Planning Commission Staff Report

Subject: Park City Heights Design Guidelines
Author: Kirsten Whetstone, MS, AICP
Date: August 24, 2016
Type of Item: Ratification of amended Park City Heights Master Planned Development (MPD) Development Agreement Exhibit G – Park City Heights Design Guidelines

Park City Heights

Neighborhood Design Guide

Street Patterns

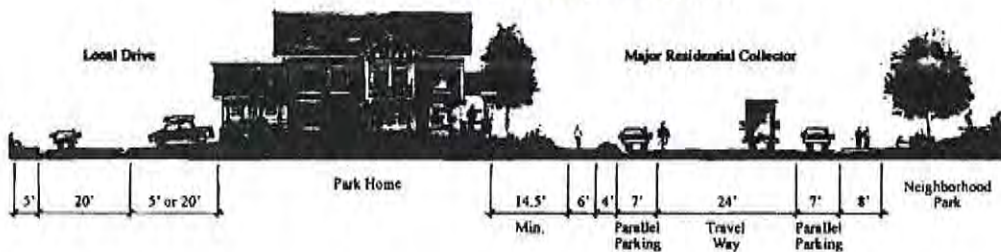
(change map after approval)

Street Patterns

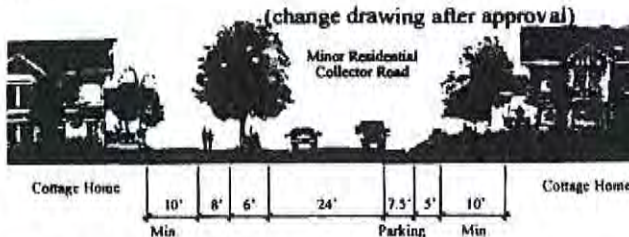
(change map after approval)

Homesteads

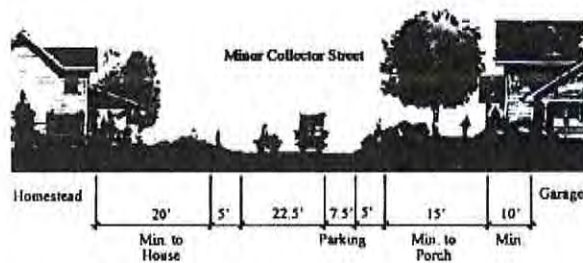
(change map after approval)
